APPLICATION NO.	FILING DATE	FIRST NAMED INVENTOR	ATTORNEY DOCKET NO.	CONFIRMATION NO.
10/612,254	07/02/2003	Michael Lambright	121046-001	3335
35684	7590	02/28/2006	EXAMINER	
BUTZEL LONG 350 SOUTH MAIN STREET SUITE 300 ANN ARBOR, MI 48104			ADAMS, GREGORY W	
			ART UNIT	PAPER NUMBER
			3652

Office Action Summary	Application No.	Applicant(s)
	10/612,254	LAMBRIGHT, MICHAEL
	Examiner	Art Unit
	Gregory W. Adams	3652

DETAILED ACTION

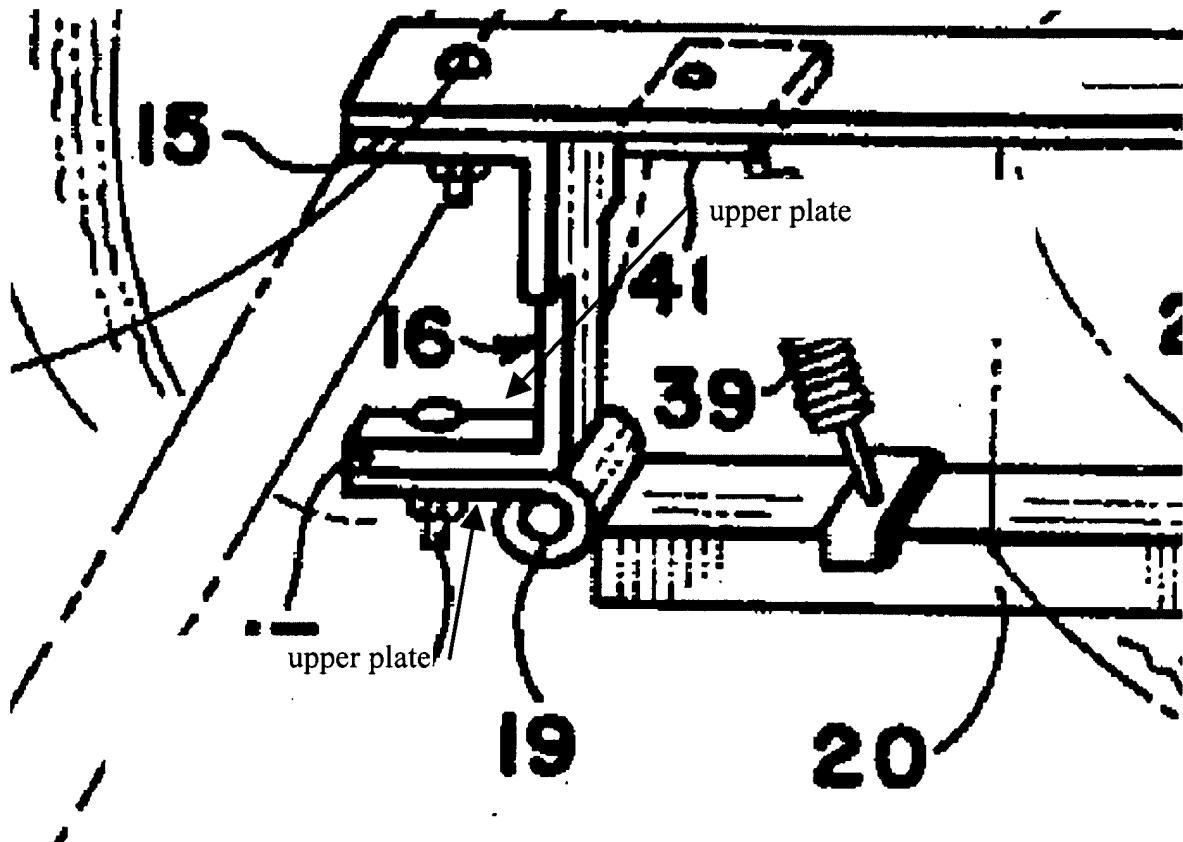
With respect to claims 1 & 9, Krakow discloses a spare tire carrier comprising a support arm 20, 21 having a central axis (indicated generally as 19), latch member, upper and lower planar guide plates (see FIG. 1 reproduced below) having a common axis whereby relative rotational movement of said upper and lower plates pivots a support arm 21 about a upper and lower planar guide plates and rotates about a central axis.

With respect to claims 8 & 16, Krakow discloses a latch mechanism (indicated generally as 33).

With respect to claim 17, Krakow discloses structure 45 (for the latch mechanism 33 to engage).

With respect to claim 18, Krakow discloses a vehicle comprising a non-motor vehicle 10.
